Subject: Addendum to Geologic Hazards Study
Shadow Run Ranch, Draft EIR
Project Issue Item Nos. 20-2 through 20-5
County Project Numbers: TM 5223; MUP 00-30; BC 00-0205
URS Project No. 27661027.10000

**TOPOGRAPHIC MAPS
EXISTING RESERVOIR
SHADOW RUN RANCH**

GENERALIZED CROSS SECTIONS D, E, F AND G EXISTING RESERVOIR SHADOW RUN RANCH

COUNTY OF SAN DIEGO TRACT NO. TM 5223 RPL-3 SHADOW RUN RANCH, PAUMA VALLEY PRELIMINARY GRADING PLAN

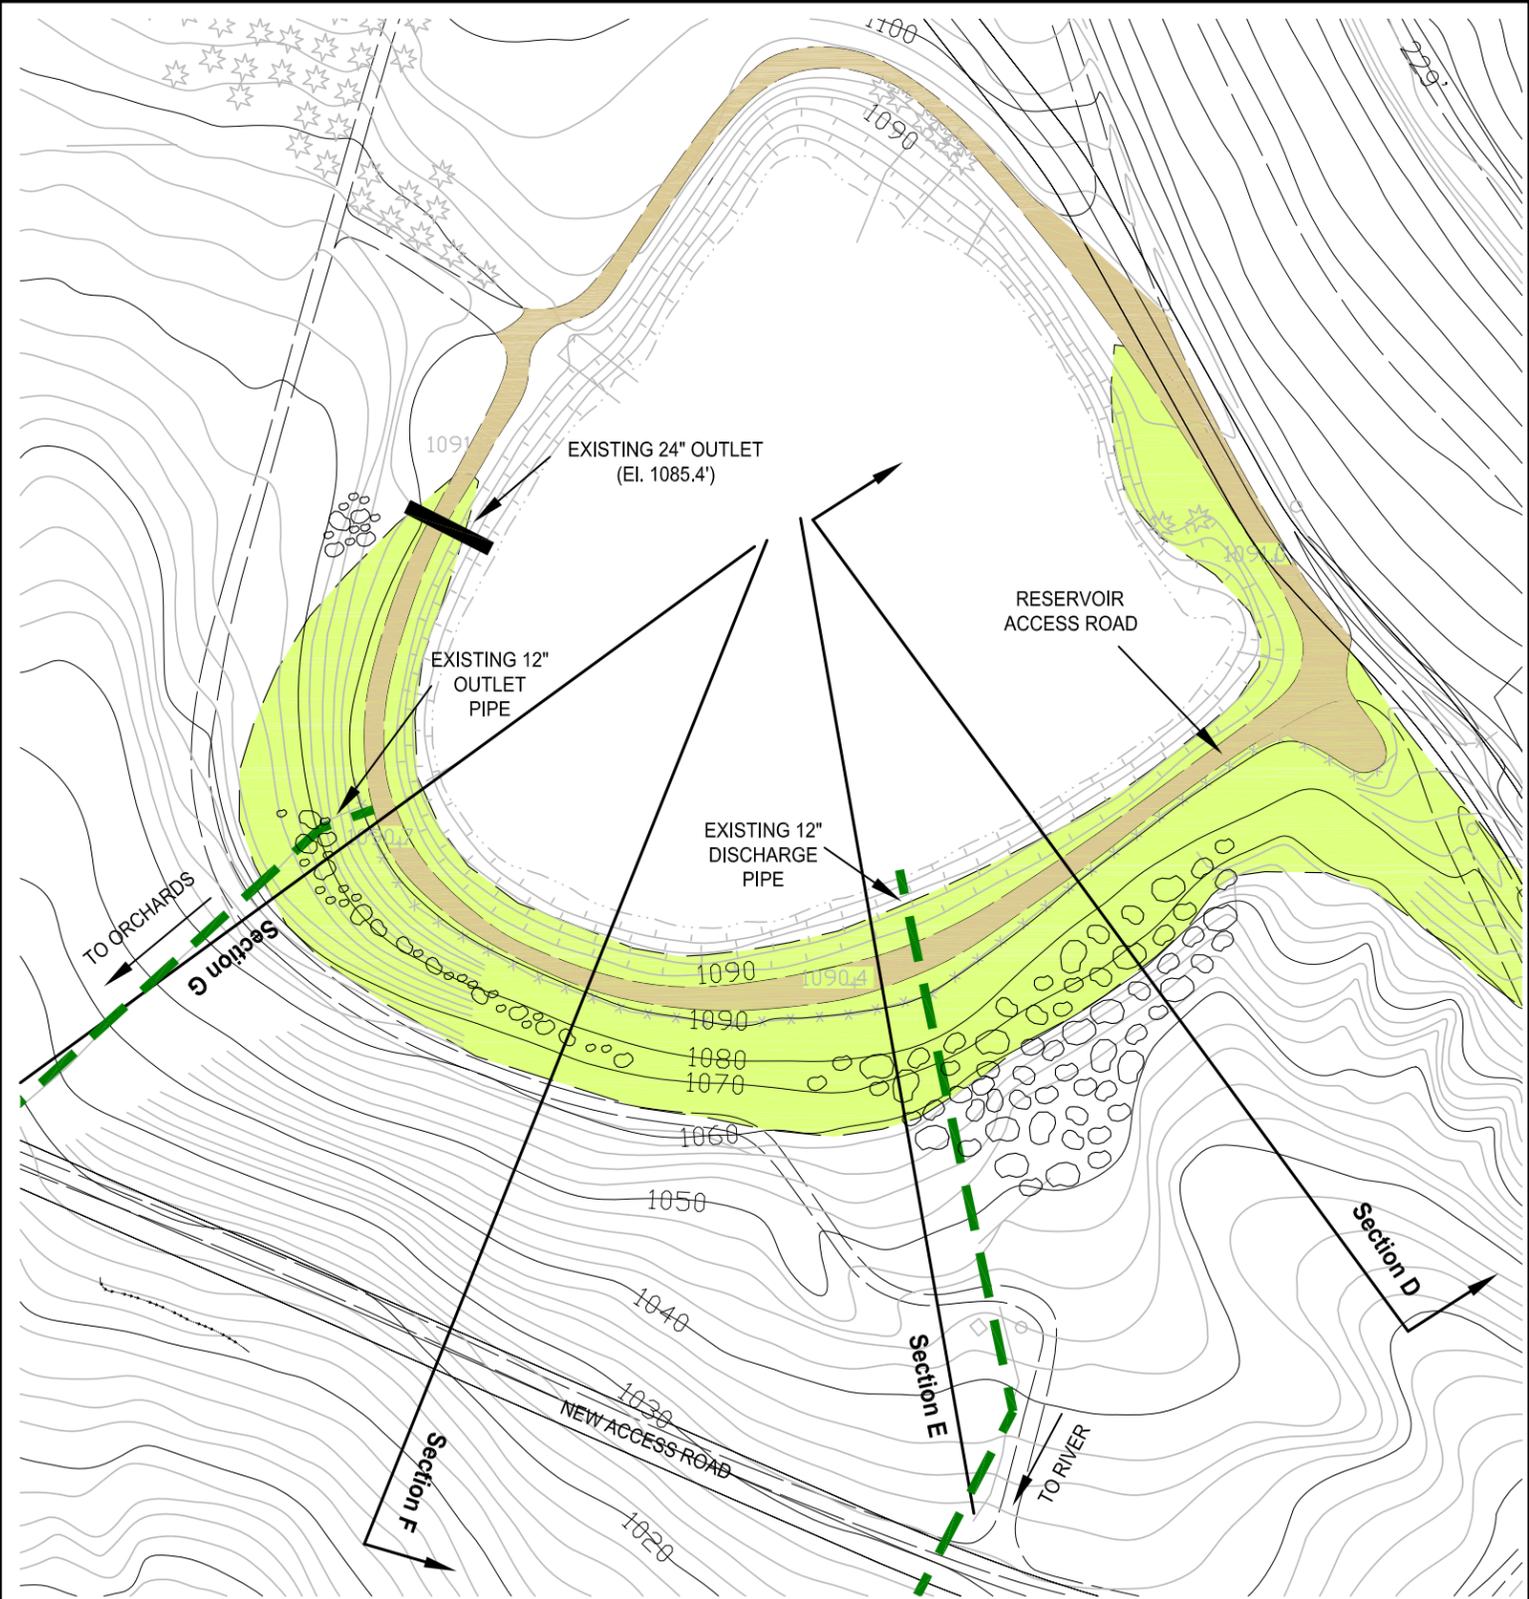
Our previous study included recommendations for building setbacks from the active Elsinore fault, mapped as the Main Fault on site. A previous version of the tentative map included a building pad to the east of the Main Fault. We had recommended that habitable structures not be sited in this area. According to the current grading plan, this issue was resolved by eliminating the house pad in question.

The new spillway will be about 20 feet wide and can accommodate up to about 2,000 cubic feet per second, according to Masson & Associates. If water flowed into the spillway during a seismic event, the spillway would direct flow away from the proposed residences into a natural drainage course below the southeast part of the reservoir. The drainage course feeds into proposed catch basins. Existing stockpiled boulders on the slope below the proposed spillway (see Figure 9) would help disperse flow.

The bowl-shaped excavation made to create the reservoir is evident on the 1961 topographic map (see Figure 9). The fill creating the low embankment slope around the west and south part of the reservoir (see current topography, Figure 9) appears to have been constructed at a later date.

With the 3-foot lowered water level, storage within the reservoir is mostly within a cut area underlain by alluvial fan deposits. The water is essentially in "dead storage" inasmuch as the existing embankment fill soils provide little containment. Therefore, the worse-case scenario of the failure of the embankment would likely not result in major, complete release of water from the reservoir, because the embankment retains only a portion of the water in storage. Deep seated instability of the embankment fill slope presents a low hazard based on our previous stability analyses.

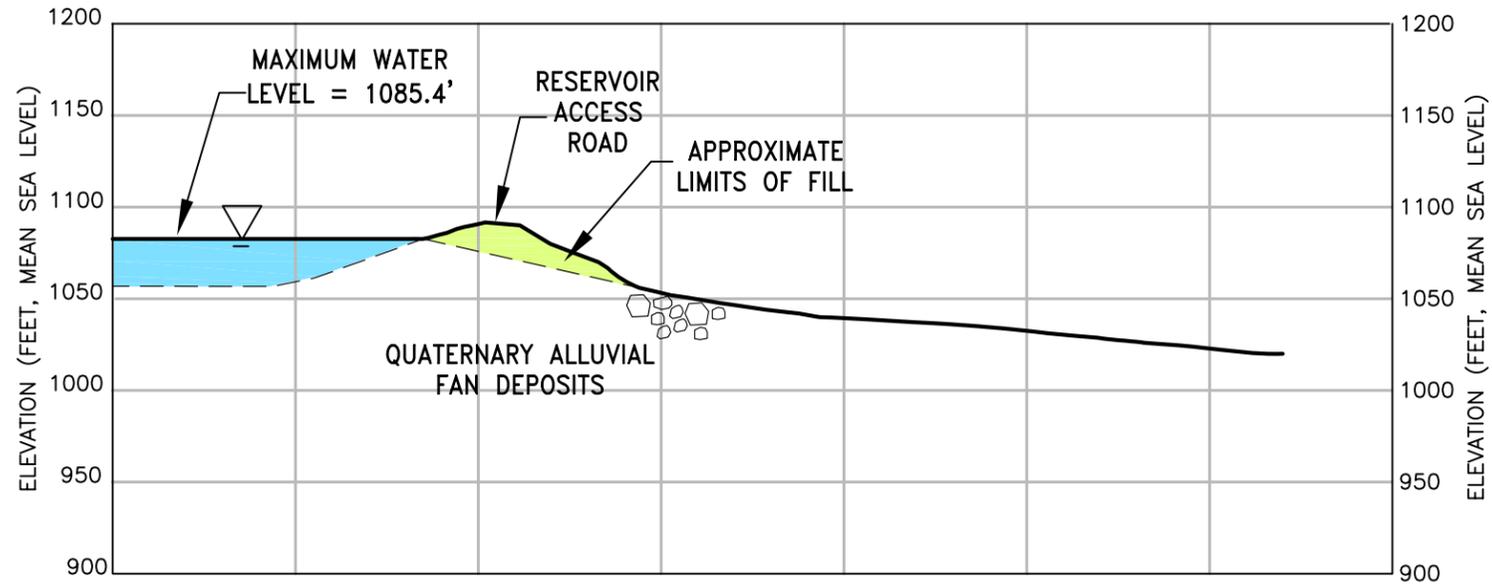
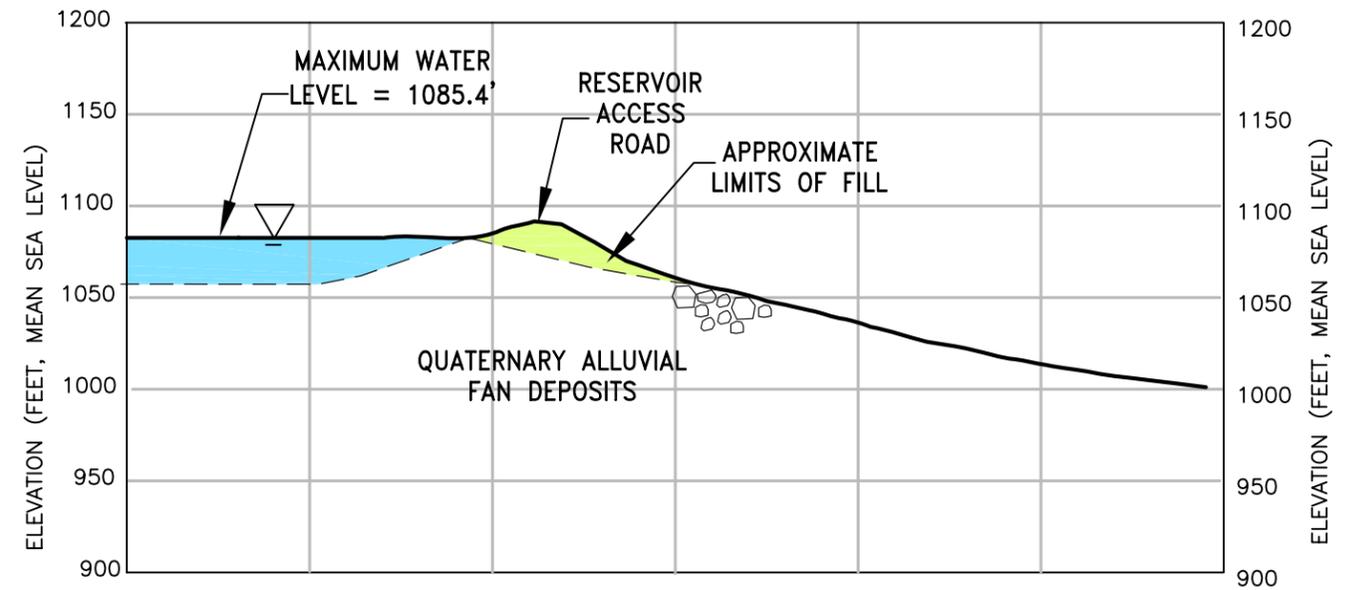
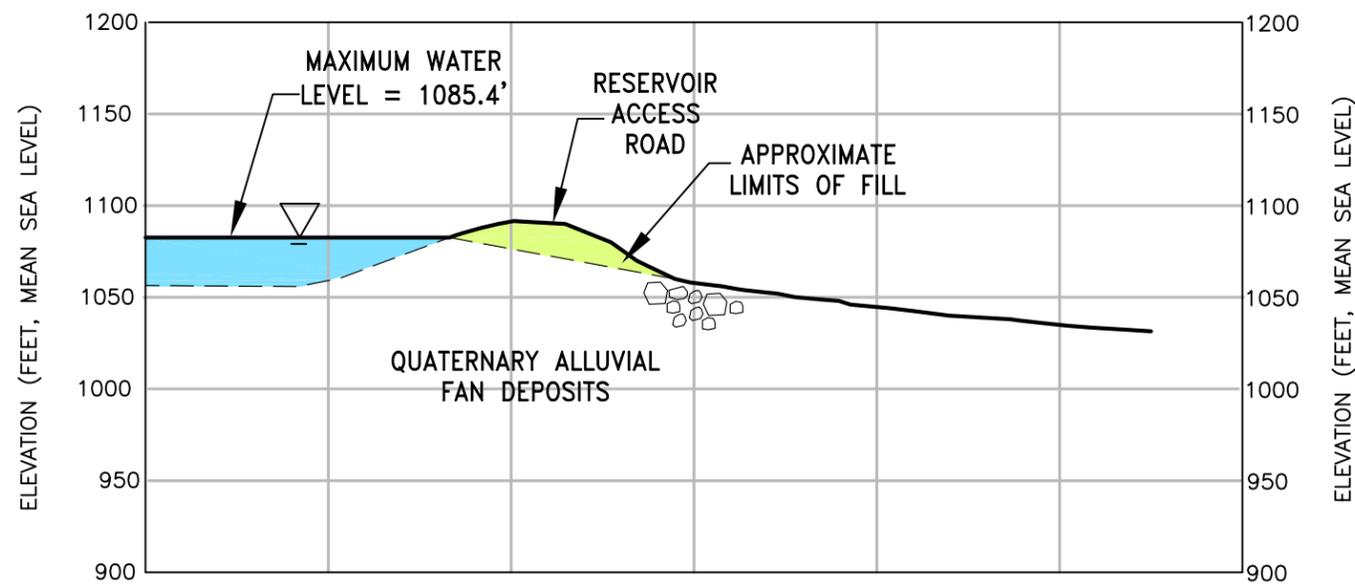
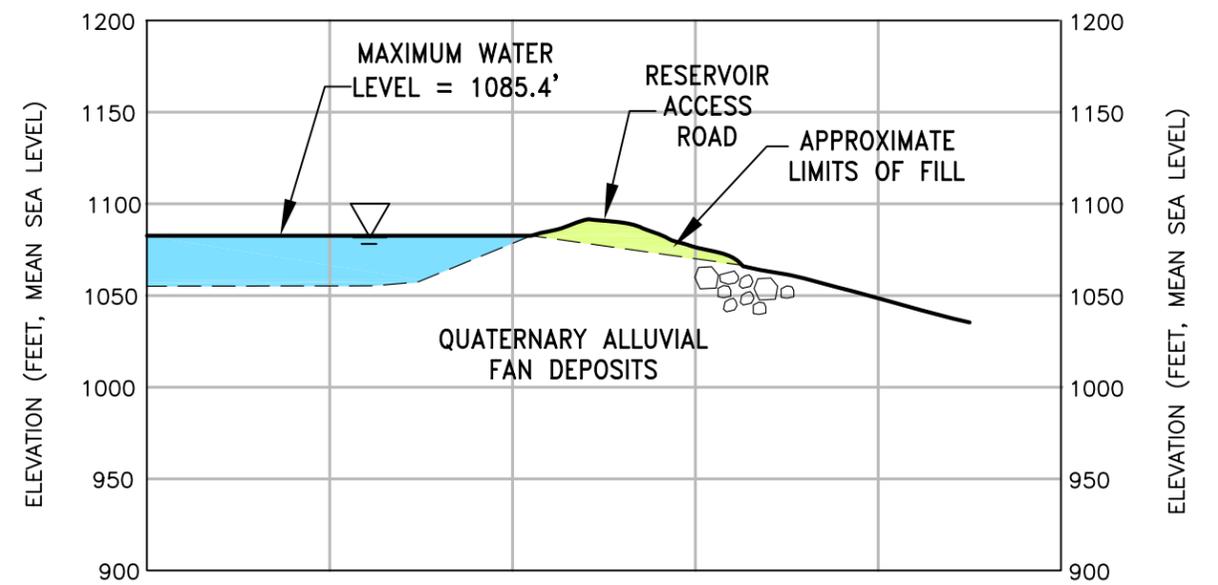
Cross sections are shown on Figure 10 from our previous report (attached). Note the water level is planned to be about 3 feet lower than the level shown on Figure 10.

The new spillway at elevation 1,082.6 feet will lower the maximum water level by about 2.8 feet. The embankment height would also be lowered from 25 feet to about 22 feet (measured from the water level to the fill slope toe) and would not be of jurisdictional size according to DSOD criteria.

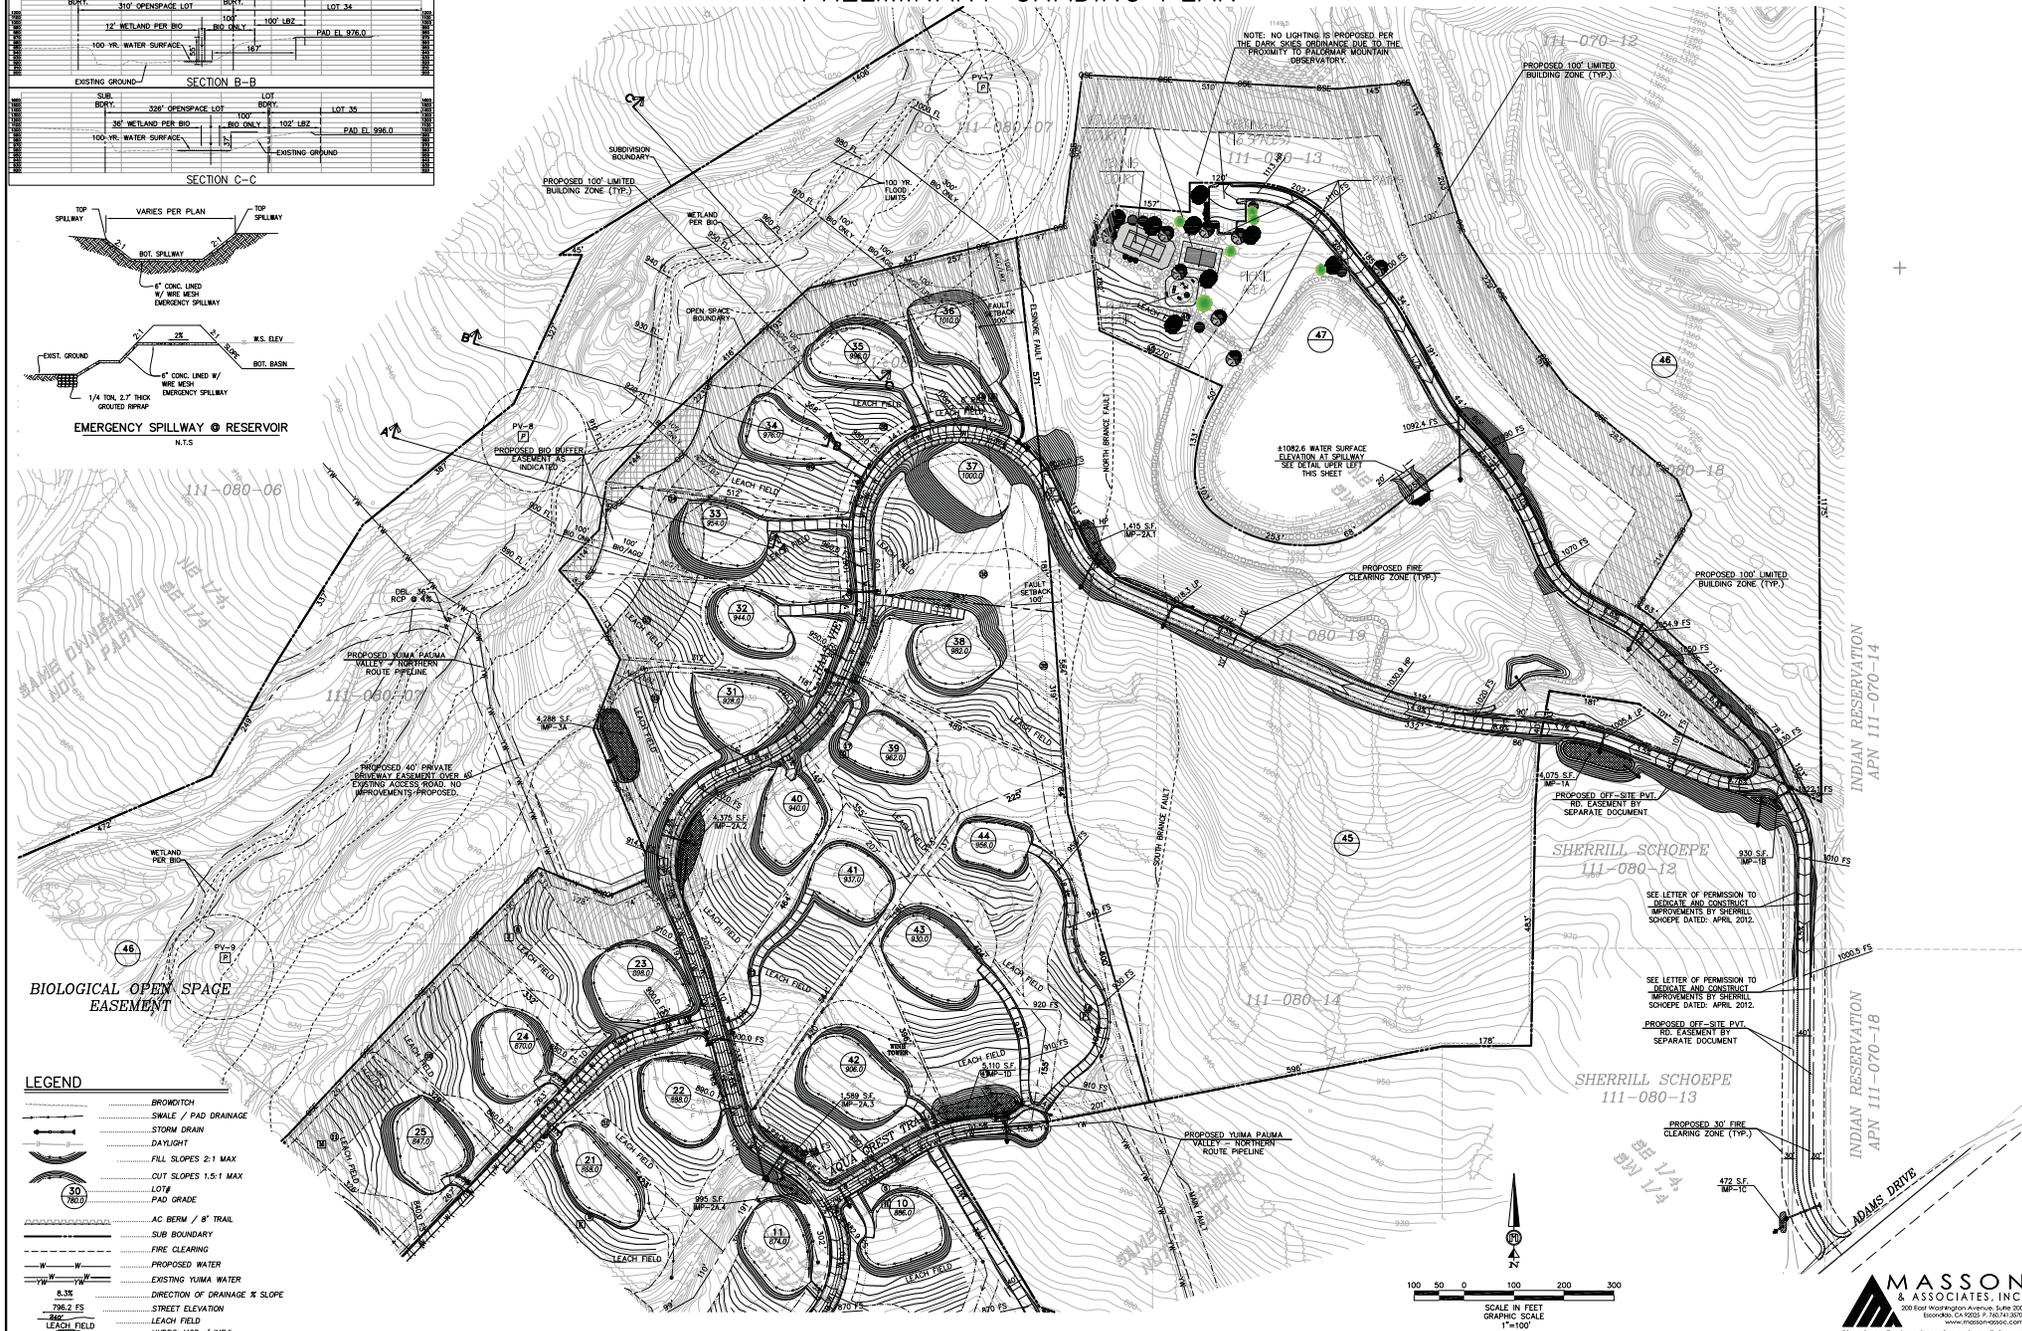
At the time of our previous study, an existing 24-inch outlet pipe maintained the reservoir water level at below about 1,085.4 feet Mean Sea Level (MSL). However, according to the preliminary grading plan prepared by Masson & Associates, Inc. a new spillway is proposed at elevation 1,082.6 feet MSL. The preliminary grading plan is included as Attachment A.

According to the preliminary grading plan (Attachment A), the project preliminary design includes new drainage features at and in the area below the reservoir, including: the new spillway, roadway brow ditches, earth swales, and hydromodification catch basins.

As shown on the attached preliminary plans, the new access road below the reservoir includes 3-foot wide brow ditches on the upslope side and several catch basins. The proposed catch basins are storm water IMP (Integrated Management Practice) bioretention facility features, which include overflow risers between 36- and 48-inches in diameter. These are primarily water quality treatment basins, which are also designed to accommodate the runoff from the 100-year storm. The overflow risers could be up-sized if necessary.

The proposed residential pads will have earth swale ditches at the top of nearby slopes. The earth swales would route any overland flow away from the proposed residences.
